ADDENDUM # 1
9/25/2020

RFP# 7608810

**TITLE: Decommissioning of the State of Rhode Island Alternative
Hospital Sites Cranston and Quonset**

SECTION 00 9111
ADDENDUM NUMBER 1

QUONSET-
ELECTRICAL
WIRING
DEMOLITION
PLAN

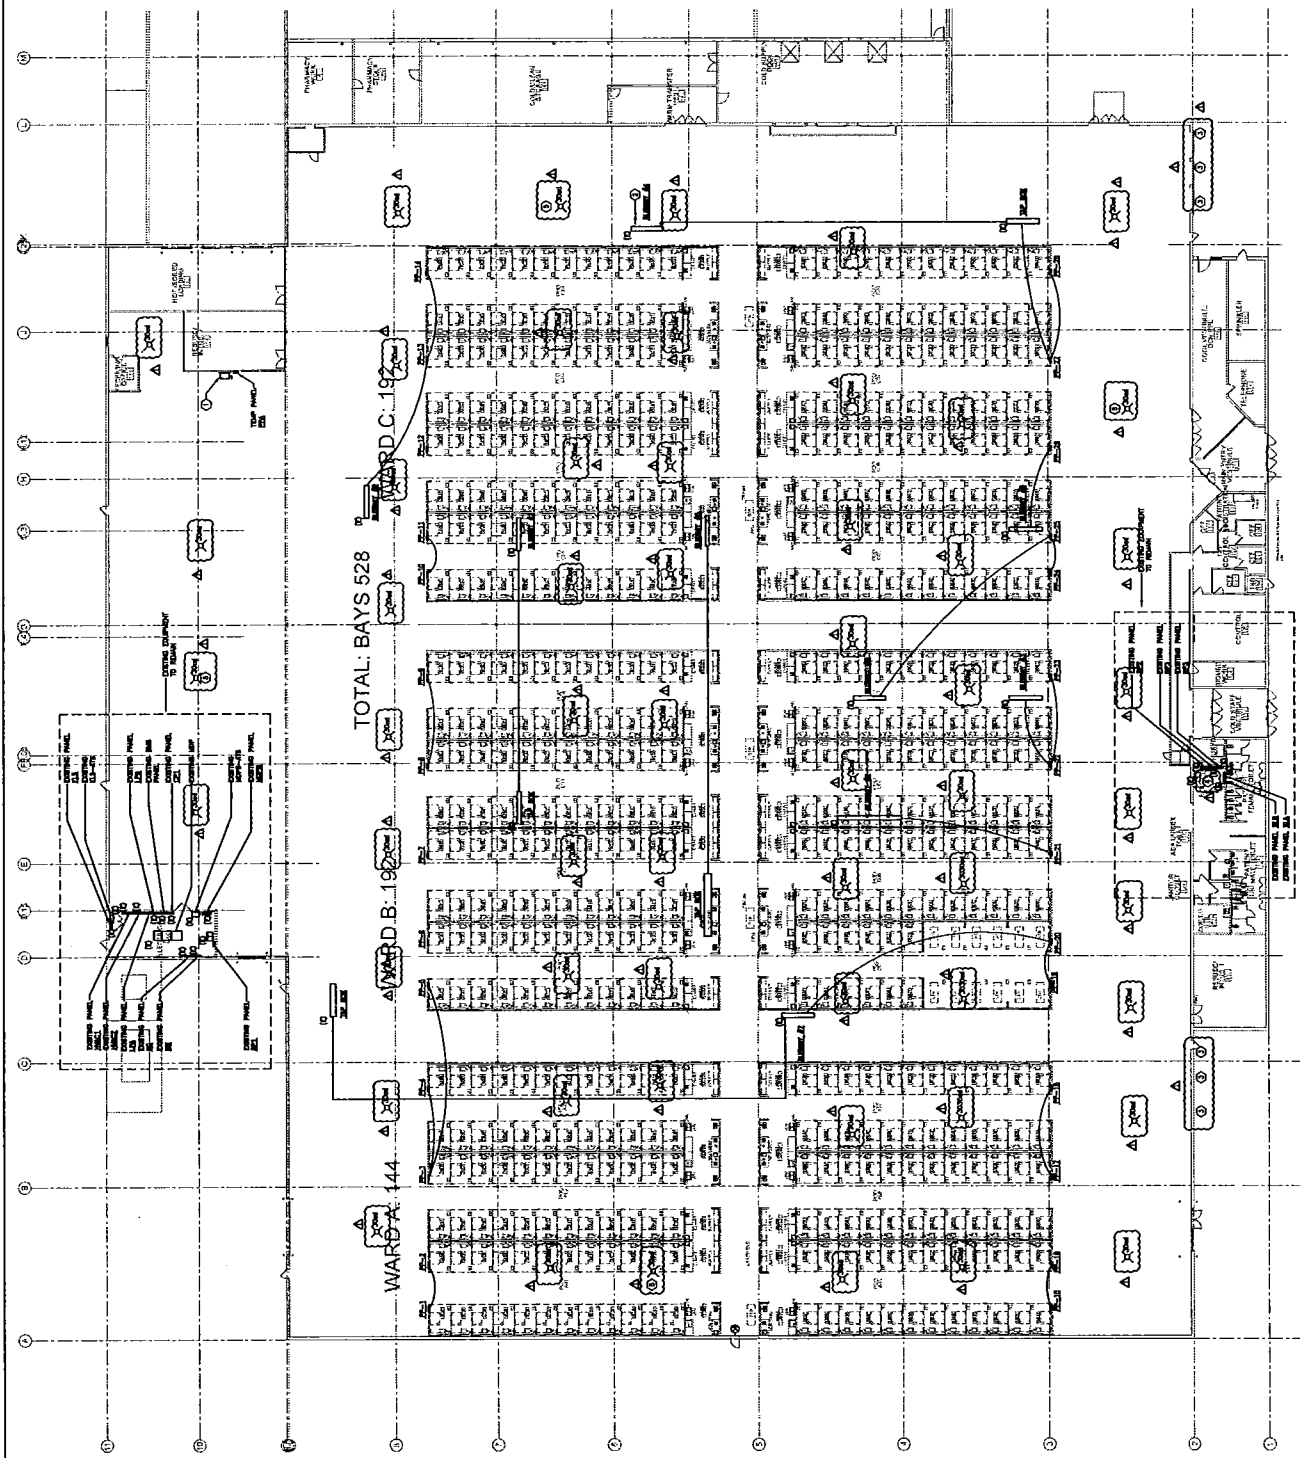
- A. Drawing E1.1 – Quonset – Electrical Wiring Demolition Plan
 - a. Four keynotes were added to clarify demolition intent. See drawing sheet for locations.
 - b. Fire alarm devices were added to the drawing.
- B. Drawing E1.2 – Quonset – Large Scale Electrical Demolition Plan
 - a. Key notes were updated on this sheet to clarify salvage and storage intent.
- C. Drawing E1.3 – Quonset – Large Scale Electrical Demolition Plan
 - a. Key notes were updated on this sheet to clarify demolition intent.

QUONSET-
**LARGE SCALE
 ELECTRICAL
 DEMOLITION
 PLAN**
E1.3

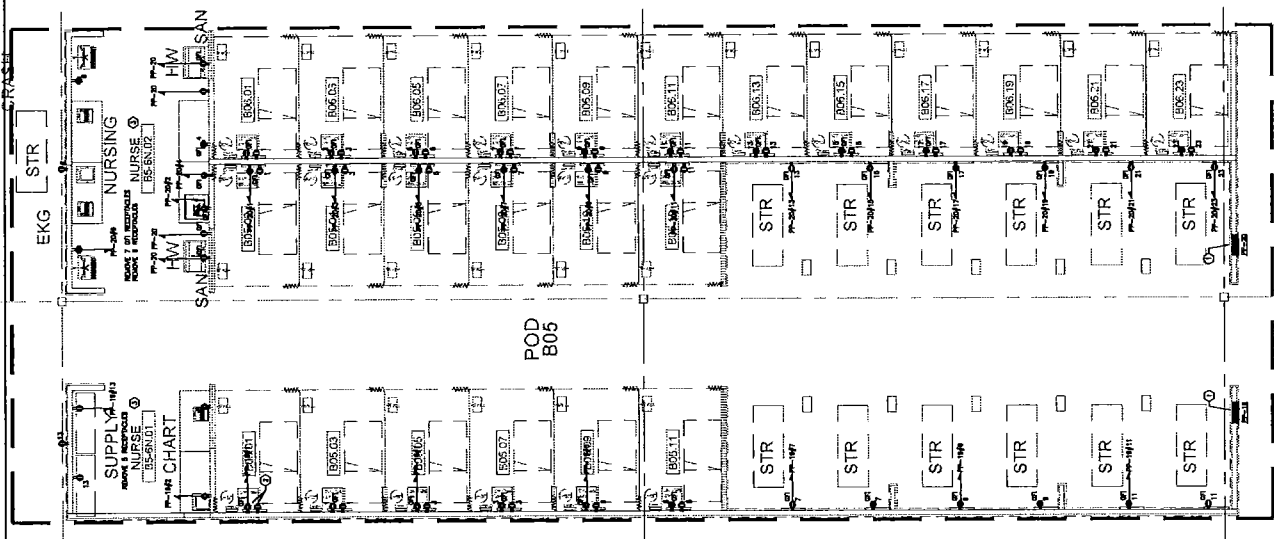
- E. Q: E1.3 The key notes are not tagged to their locations on the floor plan. Can you provide an updated plan with the key notes tagged to their appropriate locations?

A: Refer to the clarifications above and the revised drawings included with Addendum.

**CRANSTON -
ELECTRICAL
DEMOLITION
PLAN**

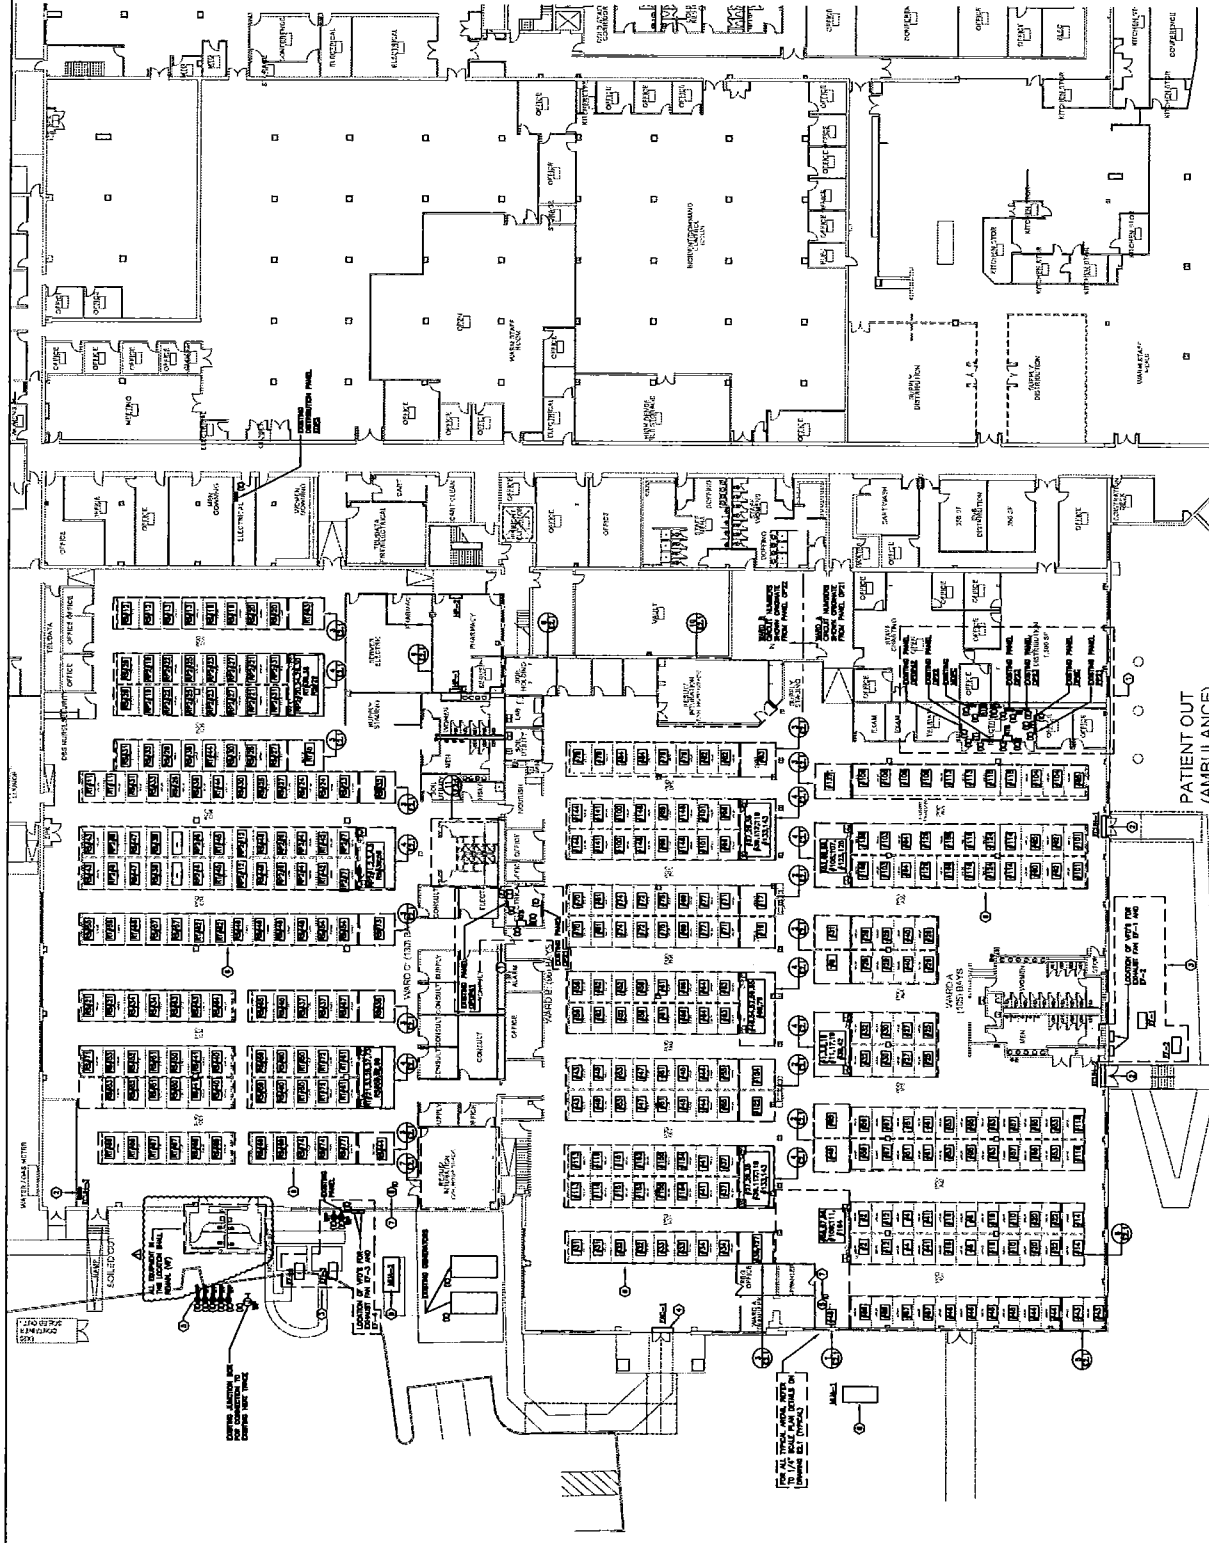
- c. Updated backgrounds showing new existing conditions
- I. E2.0 – Cranston – Electrical Demolition Plan:
 - a. Key Note 6 was updated to clarify salvage and storage intent.

- b. Updated backgrounds showing new existing conditions
